Access Compliance Report

Public Rights-of-Way

(Curb Ramps)

Intersection ID: 14585		Main Street: RUBINE_ST		Cross Street: W_TYVOLA_RD		Location: SE			
ADA ID: C3B0AED7D4E4		Ramp Type: Directional1		Initial Pass/Fail: Pass		Overall Compliance: No		Severity Score: 2.5	
Codes/Mitigation Info/Possible Solution				Field Measurements/Component Compliance

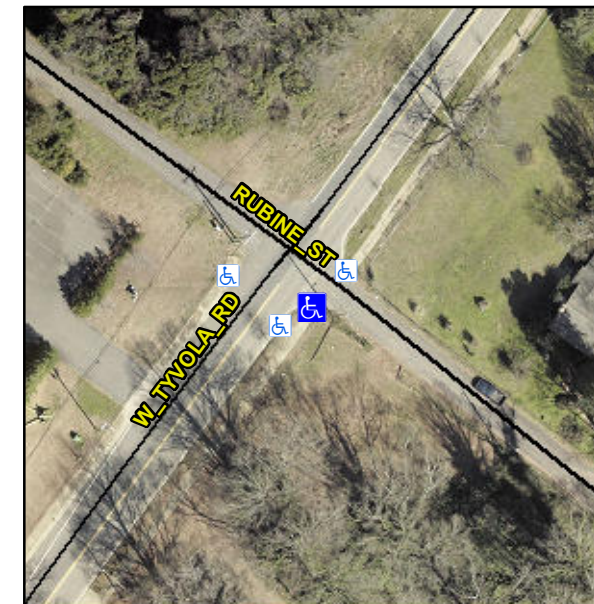
Remove & Replace Detectable Warning System.

R305.1.4, R305.2
